UNITED STATES PATENT AND TRADEMARK OFFICE

Office Action Summary

10/628,500

MIYAZAWA ET AL.

FIG. 3

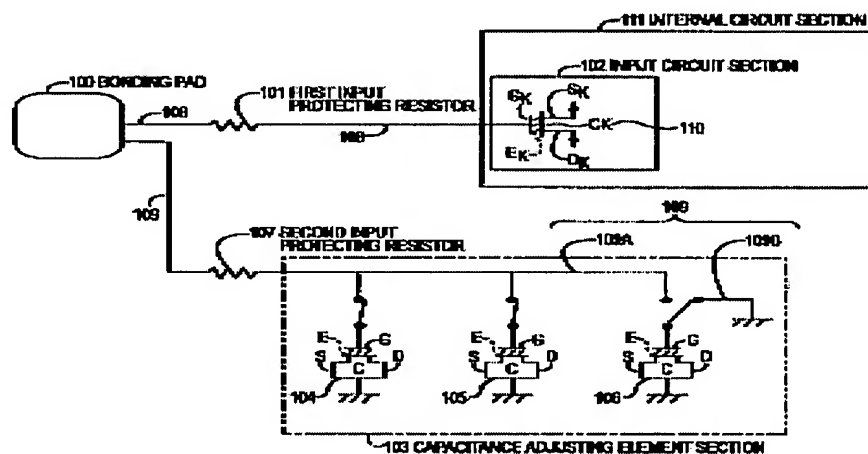
In re claim 1, **Matsui** discloses a semiconductor integrated circuit device comprising: a terminal **100**; and a first capacitance adjusting section **103** which is connected to a wiring between the terminal and a protection resistor **101** in a front stage of an internal circuit **111** (col. 7, line 39 to col. 8, line 65 and FIGS. 3 and 4),

wherein the first capacitance adjusting section adjusts terminal capacitance of the terminal, based on capacitance of the first capacitance adjusting section (col. 7, line 39 to col. 8, line 65).

In re claim 9, Matsui discloses that the semiconductor integrated circuit device according to Claim 8, wherein the well potential control section comprises: a plurality of resistors **101**, **107** which are connected in series to each other between two potential electrodes; and a plurality of switches **104**, **105**, **106** each of which is connected in parallel to each of the plurality of resistors (FIG. 3),

In re claim 10, Matsui discloses that the semiconductor integrated circuit device according to Claim 9, further comprising: a plurality of the terminals **100**; and a plurality of the first capacitance adjusting sections **103** each of which is connected to each of a plurality of the wirings **108**, **109** between each of the plurality of terminals **100** and each of a plurality of the protection resistors **101**, **107**, wherein the well potential control section controls each of a plurality of said well region potentials (col. 7, line 39 to col. 8, line 65 and FIG. 3).

Fig. 4

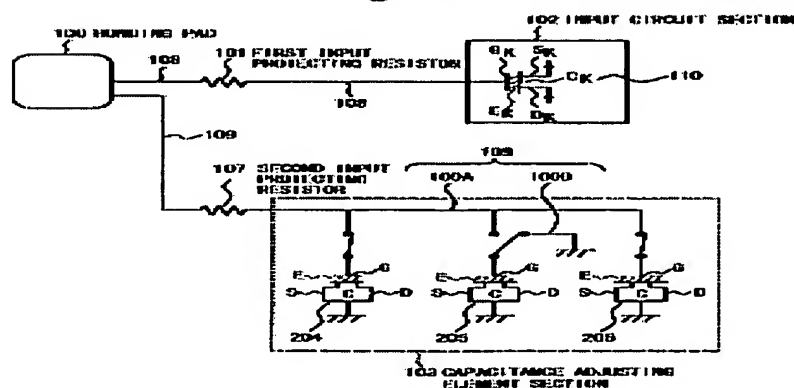
In re claim 3, Matsui discloses a semiconductor integrated circuit device comprising: a terminal **100**; and a first capacitance adjusting section **103** which is connected to a wiring between the terminal and a protection resistor **101** in a front stage of an internal circuit **111** (col. 7, line 39 to col. 8, line 65 and FIGS. 3 and 4), wherein the first capacitance adjusting section adjusts terminal capacitance of the terminal, based on capacitance of the first capacitance adjusting section (col. 7, line 39 to col. 8, line 65), wherein the first capacitance adjusting section comprises a first adjusting capacitor which adjusts the terminal capacitance (col. 7, line 39 to col. 8, line 65 and FIG. 3), and wherein the first adjusting capacitor comprises: a first semiconductive portion which is composed of a first well region formed in a substrate with the internal circuit and having a conductive type opposite to that of the substrate, and a second semiconductive portion which is opposite to the first semiconductive portion and is composed of a first diffusion layer region formed in the first well region and having the same conductive type as that of the substrate (col. 7, line 62 to col. 8, line 39 and FIG. 4).

In re claim 7, Matsui discloses that the first capacitance adjusting section comprises a first adjusting capacitor which adjusts the terminal capacitance, the first adjusting capacitor comprises: a first semiconductive portion which is composed of a first well region formed in a substrate with the internal circuit and having a conductive type opposite to that of the substrate, and a second semiconductive portion which is opposite

to the first semiconductive portion and is composed of a first diffusion layer region formed in the first well region and having the same conductive type as that of the substrate (col. 7, line 62 to col. 8, line 39 and FIG. 4).

In re claim 8, Matsui discloses that the semiconductor integrated circuit device according to Claim 7, further comprising: a well potential control section wherein the first capacitance adjusting section further comprises a second adjusting capacitor which adjusts the terminal capacitance based on controlling a well region potential by the well potential control section, the second adjusting capacitor comprises: a third semiconductive portion which is composed of a second well region formed in the substrate and having a conductive type opposite to that of the substrate, a fourth semiconductive portion which is opposite to the third semiconductive portion and is composed of a second diffusion layer region formed in the second well region and having the same conductive type as that of the substrate, and the well potential control section controls the well region potential of the second well region (col. 7, line 62 to col. 8, line 39 and FIG. 4).

switches **104, 105, 106** each of which outputs signal potentials corresponding to turn on and off of the each of plurality of switches, and a plurality of signal holding sections each of which holds corresponding each of a plurality of the signal potentials wherein the switching control section controls the capacitance of the second capacitance adjusting section based on the plurality of signal potentials (FIG. 4).

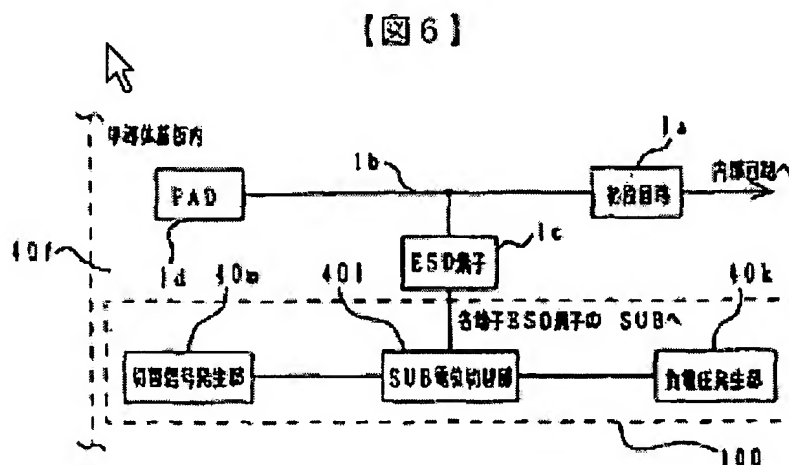
Matsui does not explicitly disclose that the semiconductor integrated circuit device according to Claim 1, further comprising: a protection circuit which is connected to the wiring between the terminal and the first capacitance section and protects the internal circuit.

Yusho, however, discloses a protection circuit (ESD) 1c, which is connected 1b to the wiring 20b between the terminal (PAD) 1d and the first capacitance section and protects the internal circuit (Patent Abstracts Of Japan and FIGS. 4 and 6 and related text).

Therefore, it would have been obvious to one of ordinary skill in the art at the time of the invention was made to combine the teaching of Matsui and Yusho to enable the protection circuit which is connected to wiring between the terminal and the first capacitance adjusting section of Matsui to be formed and furthermore to provide a

semiconductor device having a transistor for electrostatic protection is formed in the vicinity of a pad, and the terminal capacitance of the semiconductor device is made controllable (Abstract, Yusho).

Fig. 6

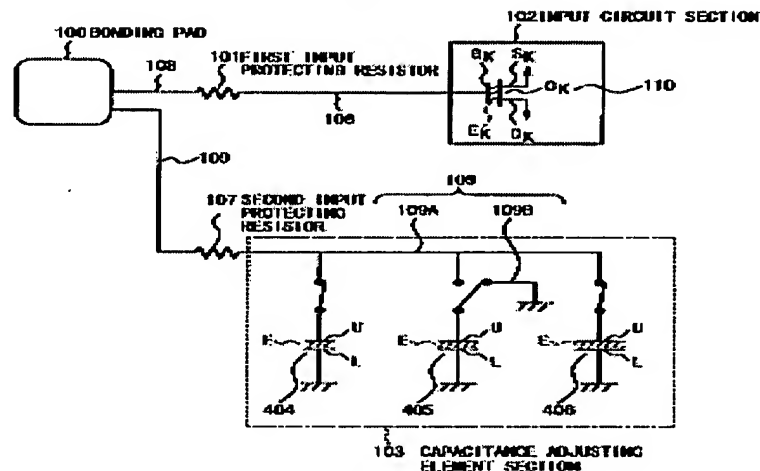
In re claim 15, **Matsui** discloses that the semiconductor integrated circuit device according to Claim 3, further comprising: a second capacitance adjusting section which is connected to a wiring between said first capacitance adjusting section and said internal circuit, wherein the second capacitance adjusting section adjusts the terminal capacitance

based on capacitance of the second capacitance adjusting section; and a switching control section which controls said capacitance of said second capacitance adjusting section (col. 10, line 54 to col. 11, line 10 and FIG. 6).

In re claim 16, Matsui discloses that the semiconductor integrated circuit device according to Claim 15, wherein the switching control section comprises: a plurality of switches each of which outputs signal potentials corresponding to turn on and off of each of plurality of switches, and a plurality of signal holding sections each of which holds corresponding each of a plurality of said signal potentials, wherein the switching control section controls the capacitance of the second capacitance adjusting section based on the plurality of signal potentials (FIG. 6).

In re claim 17, Matsui discloses that the semiconductor integrated circuit device according to Claim 16, wherein the second capacitance adjusting section comprises: a plurality of third adjusting capacitors each of which capacitance is variable based on corresponding the each of the plurality of signal potentials, wherein the second

capacitance adjusting section adjusts the plurality of third adjusting capacitors based on the signal potential (col. 10, line 54 to col. 11, line 10 and FIG. 6).

In re claim 18, Matsui discloses that the semiconductor integrated circuit device according to Claim 17, further comprising: a plurality of said terminals; and a plurality of the second capacitance adjusting sections each of which is connected to each of a plurality of the wirings between each of the plurality of the first capacitance adjusting sections and each of a plurality of the internal circuits, wherein the switching control section controls each of a plurality of the capacitances of the plurality of second capacitance adjusting sections (col. 10, line 54 to col. 11, line 10 and FIG. 6).
